SUNDRY NOTICES AND REPORTS ON WELLS
Do not use this form for proposals to drill or to re-enter an abandoned well. Use form 3160-3 (APD) for such proposals.

SKELLY #70

Proposed Wellbore Diagram

Skelly Unit 70
Forest Oil Corporation
December 3, 2007
Plug and Abandonment
Conditions of Approval

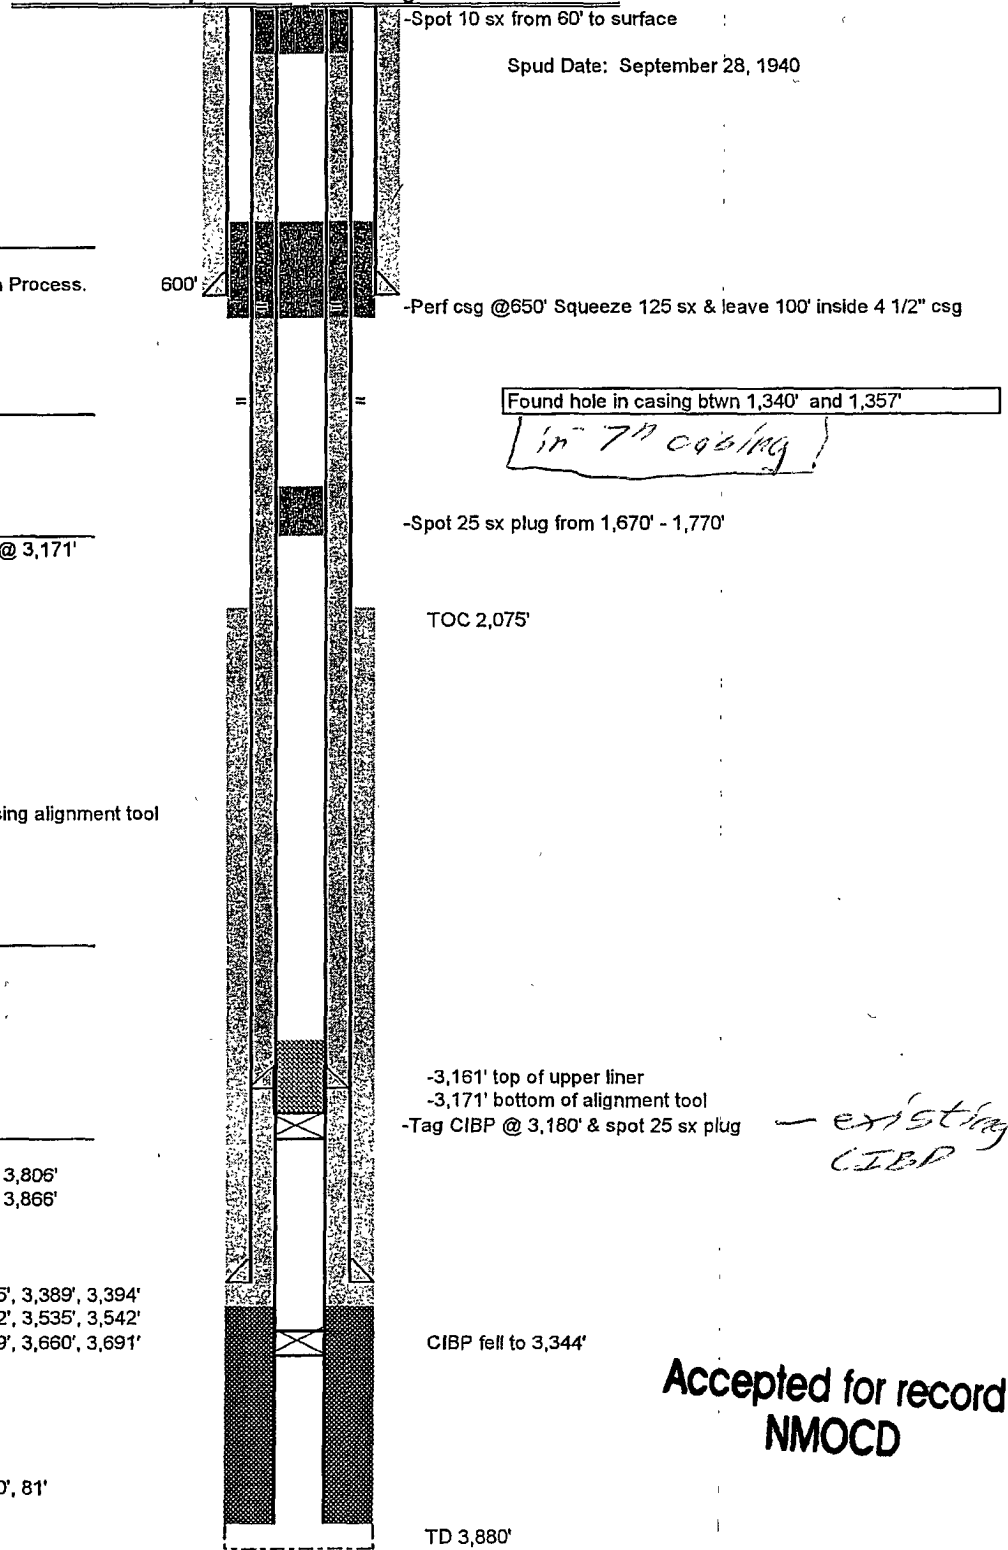
1. Tag plug at 3180' and place 25 sack plug.
2. Circulate hole with mud laden fluid.
3. Spot 25 sack plug from 1925 – 1825 and tag plug. WOC 4 hours. Base of Salt.
4. Perforate casing at 750' to get below top of Salt and attempt to establish circulation to surface through the 7" x 10.75" annulus. If circulation is established, circulate cement to surface. If not, squeeze the proposed 125 sack cement plug. Plug to be tagged at 550' or shallower. WOC 4 hours.
5. All annuli at surface must be sealed. If cement did not circulate on previous step, casing must be perforated and cement circulated to surface in the 7" x 10.75" annulus. Plug to be a minimum of 60' in length.
6. Cut off wellhead and install dry hole marker.
